TYRONE TOWNSHIP PLANNING COMMISSION
REGULAR MEETING AGENDA
May 11, 2021 7:00 p.m.

Lake Urban Crossing Preliminary PUD Plan

Planned Unit Development Concept Review for Tyrone Township, Michigan

Applicant: David McLane, AMAG LLC (agent)
Owner: Lake Urban Crossings LLC
Others with Interest: unknown
Request: Concept review of residential planned unit development

REVISIONS	DRN. BY:	J.R.B.	03.22.2021	SHEET NO: P-1
	DSN BY:	J.R.B.	"	
	CHK'D BY:	J.B.M.	"	
	APPR BY:	J.B.M.	"

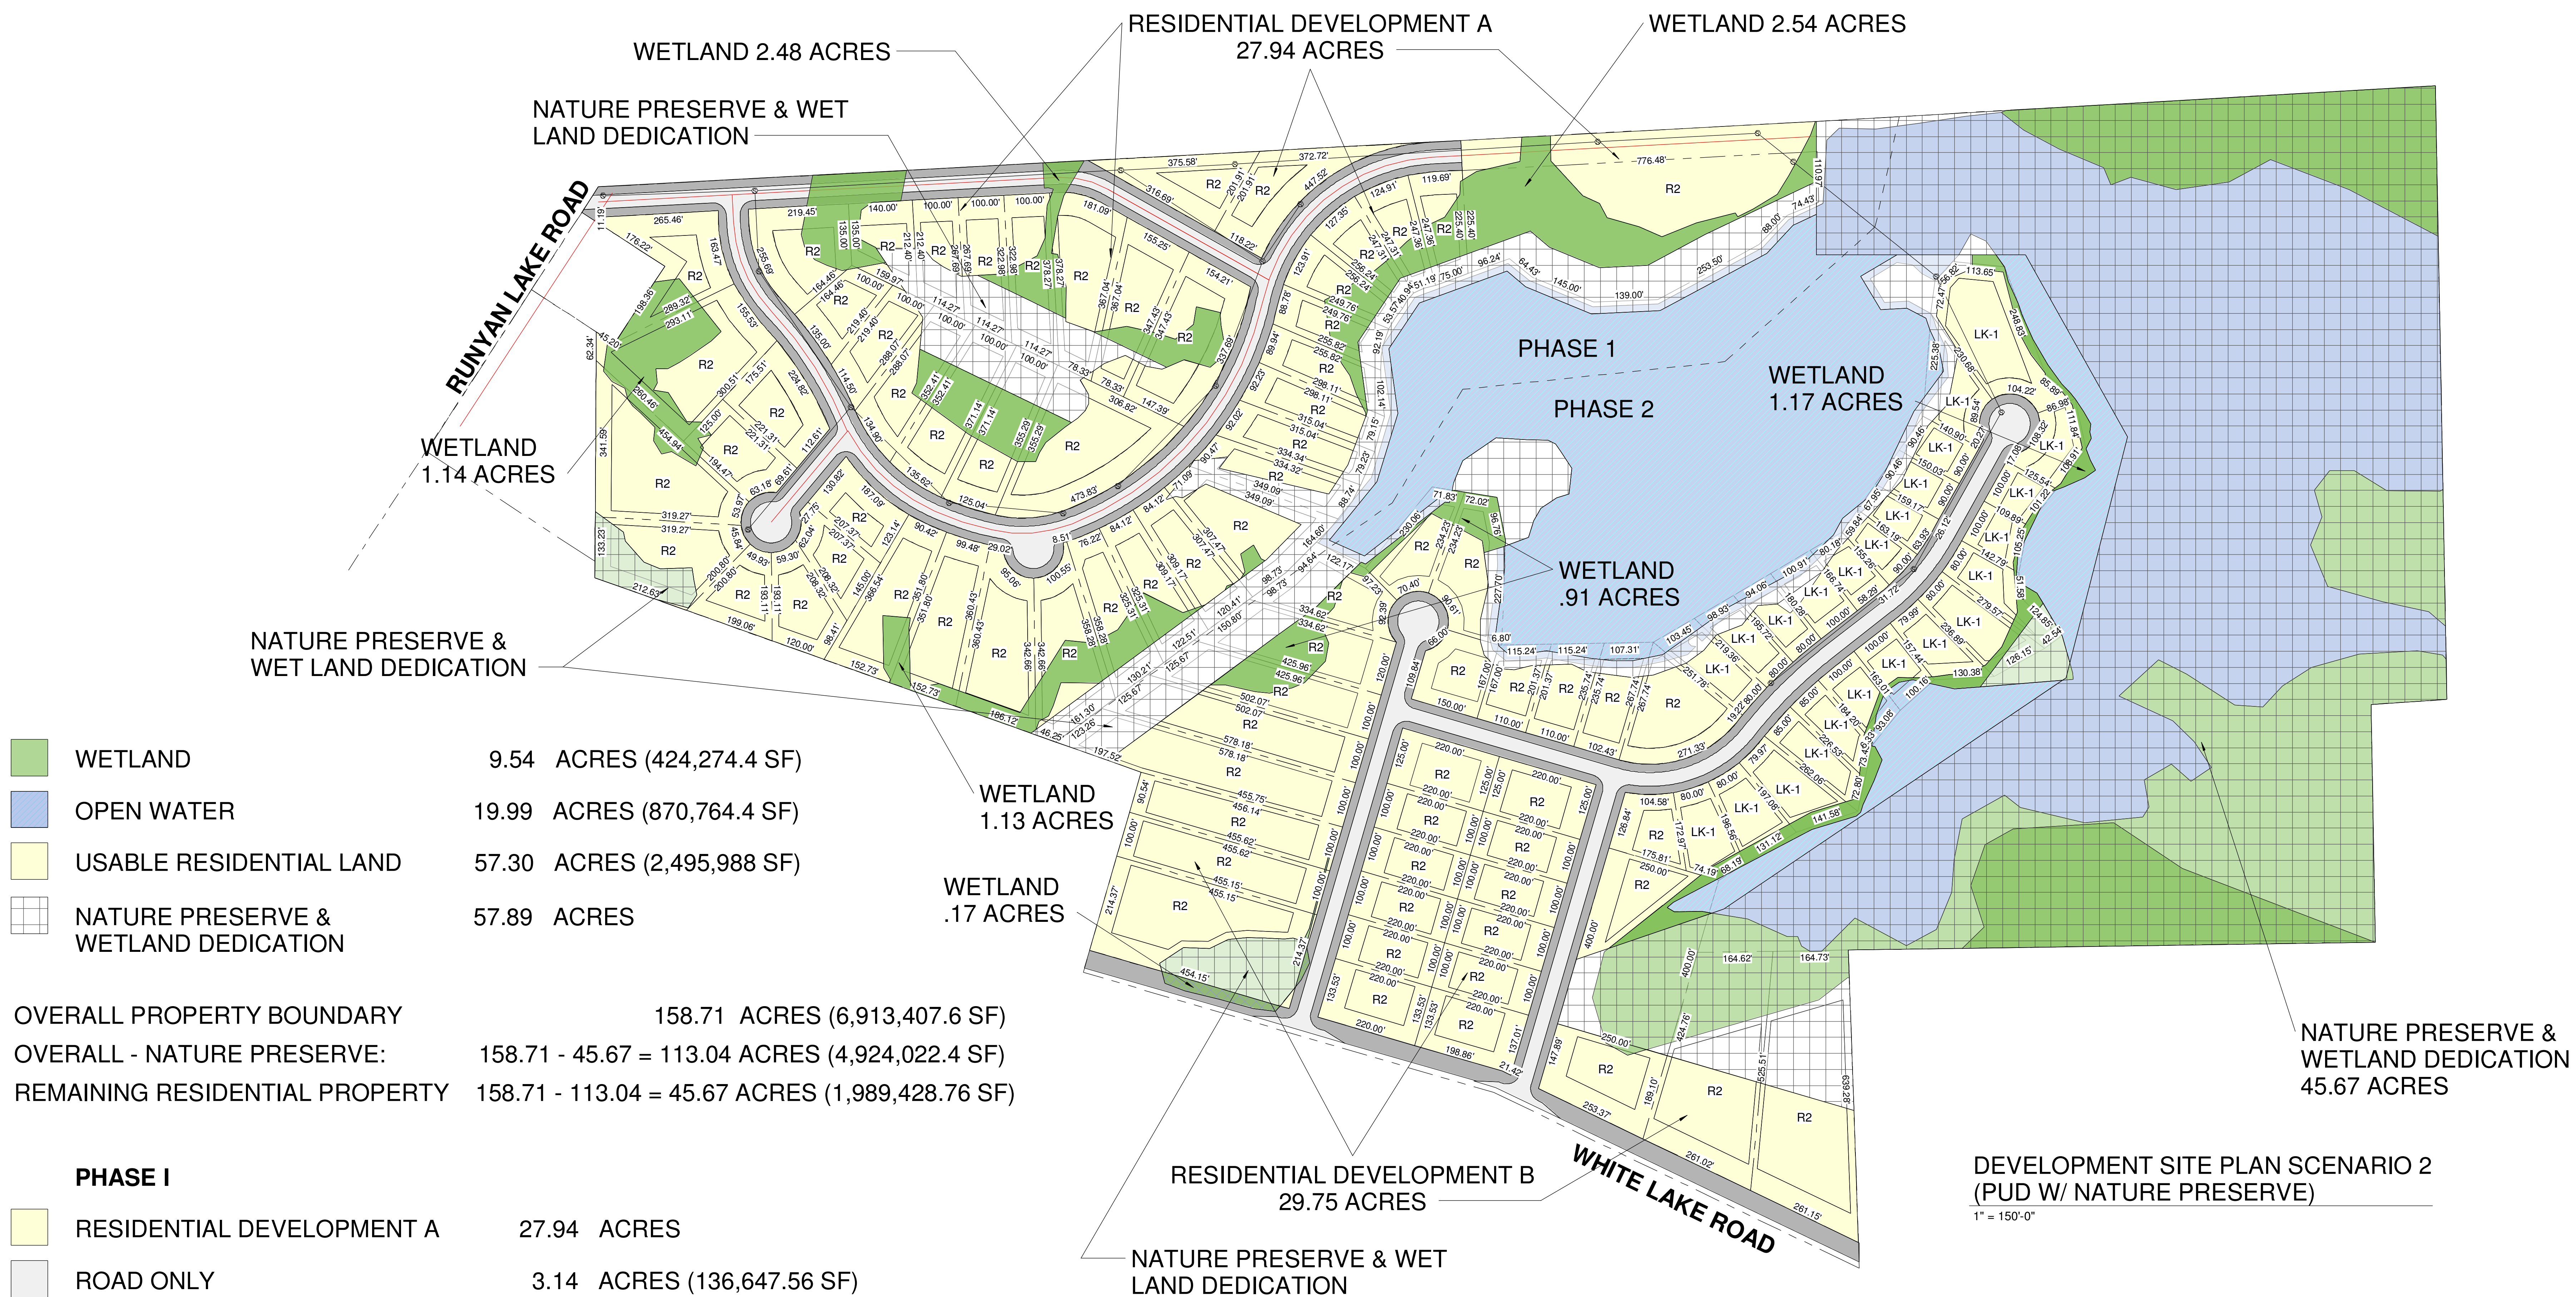
Comments: *It does not appear that the base parallel plan has been prepared using the developmental standards of the current RE Rural Estate district, nor does it appear to be fully consistent with zoning districts identified with the Future Land Use Map in Table 11-1 of the Zoning Ordinance, which calls for R-1 Single Family Residential or R-2 Single Family Residential on the western portion of the site and FR Farming Residential on the eastern portion of the site.*

Comments: The supplied parallel plan does not appear to meet the developmental standards for the current zoning district or zoning districts associated with the Future Land Use Map, per Table 11-1, nor does it show any of the southern portion of the site. Unless a zoning map amendment is approved, the current parallel plan does not provide appropriate guidance for calculating allowable lots or density bonuses.

The parallel plan should be prepared according to the current zoning districts or the zoning districts that correspond with the Future Land Use Map, as identified in Table 11-1. That would place the western portion within the R-1 or R-2 Single Family Residential district and the eastern portion within the FR Farming Residential district. It should also show the entire site. It is difficult to accurately assess the potential scenarios without a parallel plan described above.

It is likely that a revised parallel plan would show fewer buildable lots, which would reduce the number of buildable lots available through a planned unit development approval.

Map 1 – Current Zoning Map

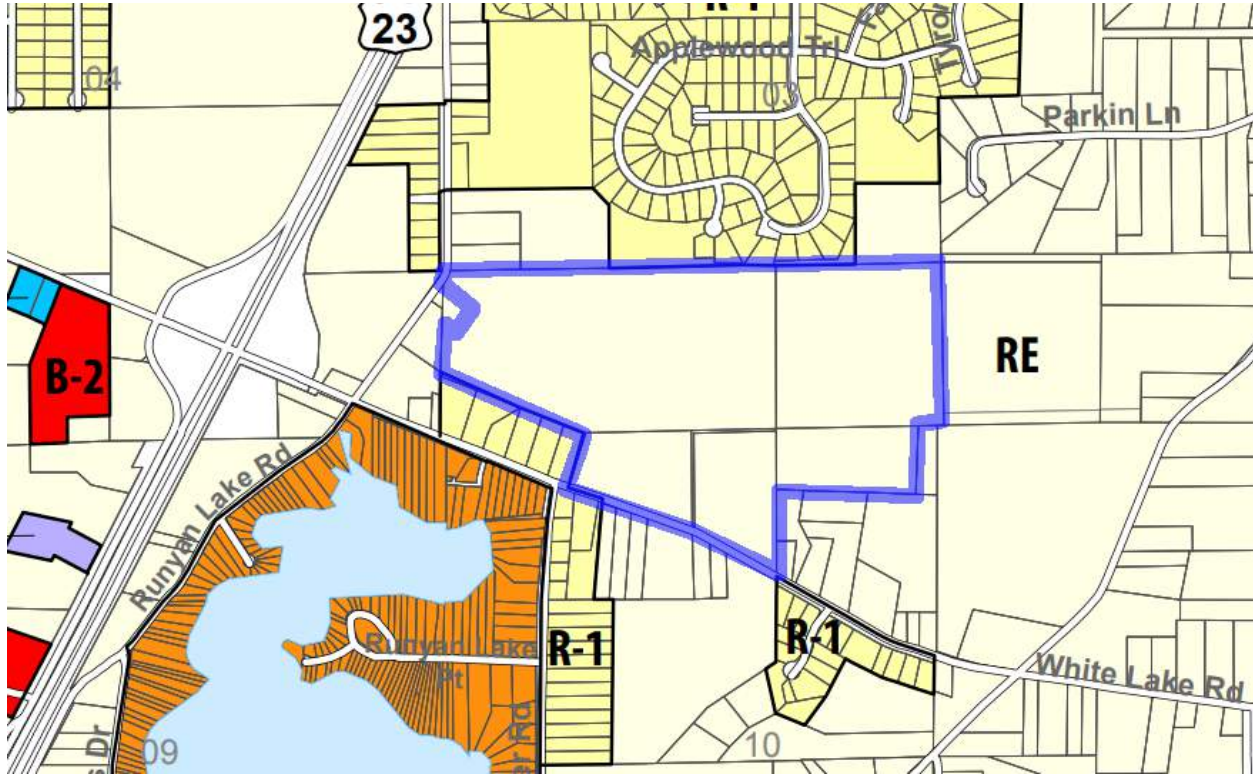
Comments: Based on the Future Land Use Map (later in this report) and the intents above, it may be appropriate for the western portion of the property to receive a zoning map amendment to the R-2 Single Family Residential district.
